Service manual

RECORDERS N4450

Service Information

Fig. 2

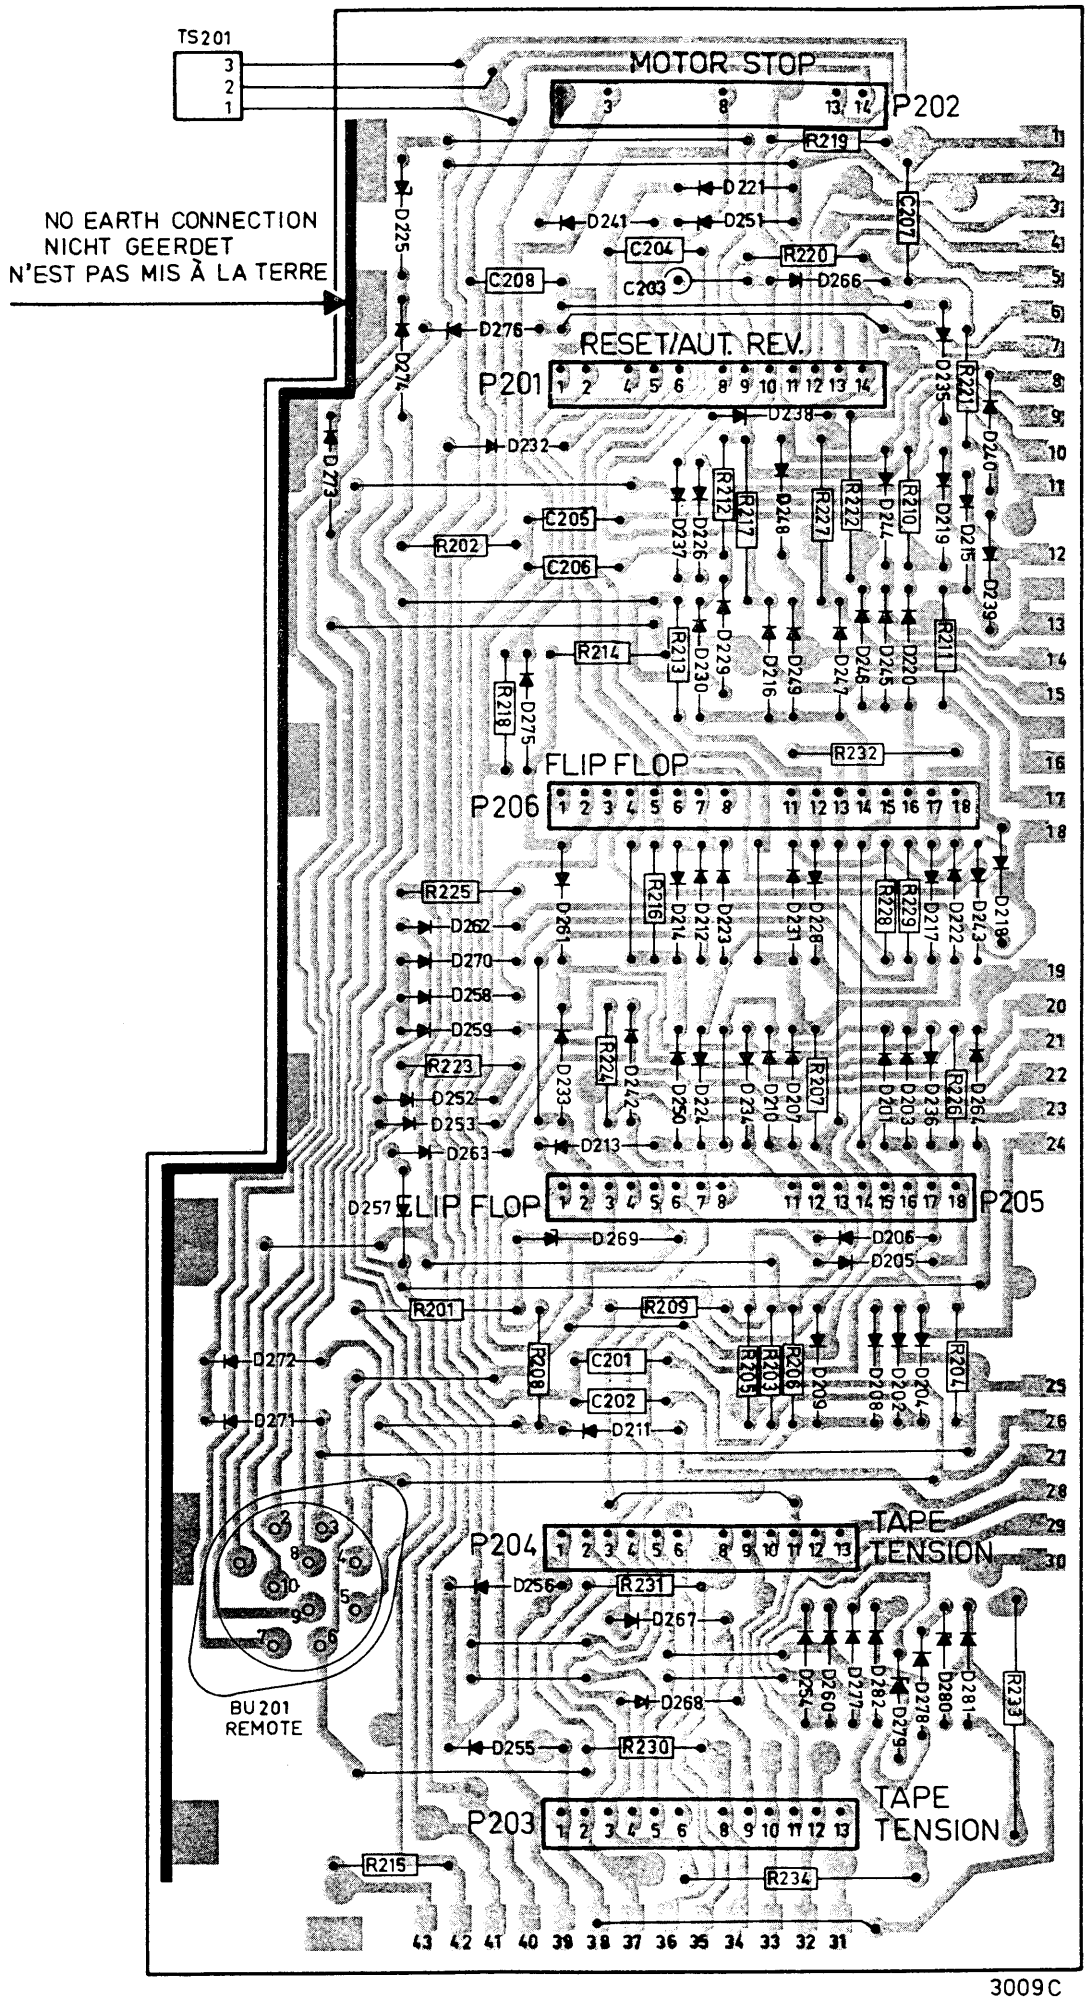
. In recorders, marked from WR09/304, resistor R202 (2.2 kΩ - 1/8 W ± 5 %) has been added on p.c. board 2 (see Fig. 2). Furthermore, the diodes D10 and D11 (BZX88/C3V3) on the RESET/AUTOMATIC REVERSE UNIT P201 have been replaced by BZX79/C4V7. This modification has been introduced because the recorder sometimes stopped at any moment when the remote control unit N6719 was used.

. In recorders, marked from WR09/323, the following modifications have been made on p.c. board 2 (see Fig. 2):
- the print tracks have been modified;
- the diodes D277, 278, 279, 280, 281, 282 and the resistors R232, 233, 234 are fitted to the component side.

SPEED CONTROL UNIT — N4418, N4450, N4510

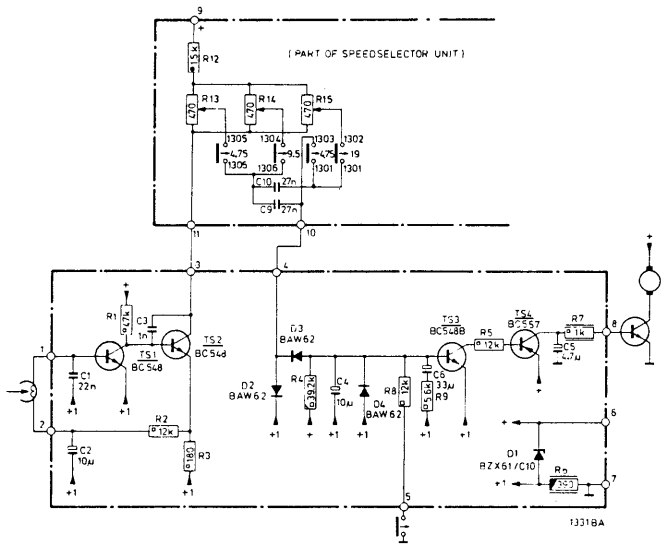
- D1 - BZX79/C10 has been replaced with BZX61/C10. Thus, the reliability has been improved.
  This modification has been made in recorders marked from WR07/317 (N4418), from WR09/316 (N4450), or from WR02/317 (N4510).
- D2,3 - BA217 have been replaced with BAW62; D4 - BA216 has been replaced with BAW62. Thus, the reliability has been improved. These modifications have been made in recorders marked from: WR07/304 (N4418), WR09/304 (N4450), WR02/304 (N4510)
- Some transistors have been replaced.

Original type	Replacement type
TS1,2 - BC148	BC548
TS3 - BC148	BC548B
TS4 - BC157	BC557

RESET-AUTOMATIC REVERSE UNIT — N4450

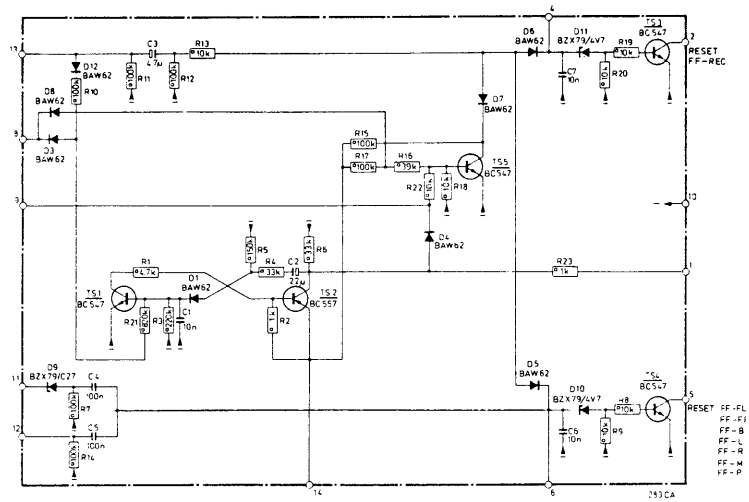
- D10, 11 - BZX88/C3V3 have been replaced with BZX79/C4V7. Thus, it has been avoided that the recorder suddenly stops when remote control N6719 is being used.
  This modification has been made in a limited number of recorders marked from WR09/240 and in all recorders marked from WR09/304.
- D9 - BZX79/C30 has been replaced with BZX79/C27. Thus, the switch clock will again function properly at too low a mains voltage.
  This modification has been made in recorders marked from WR09/333.
- D1,3,4,5,6,7,8,12 - BA217 have been replaced with BAW62. Thus, the reliability has been increased.
  This modification has been made in WR09/304.
- TS1,3,4 and 5 - BC147 have been replaced with BC547; TS2 - BC157 has been replaced with BC557.

TAPE TENSION UNIT — N4450

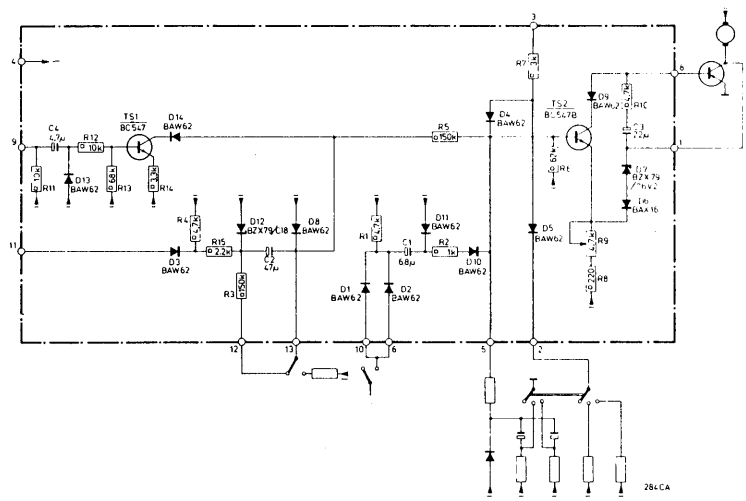
- D1,2,3,4,5,9,10,11,13,14 - BA217 have been replaced with BAW62 because of the changed range of diodes.
- TS1 - BC147 and TS2 - BC147B have been replaced with BC547 and BC547B respectively. Thus, fitting these transistors has been facilitated.
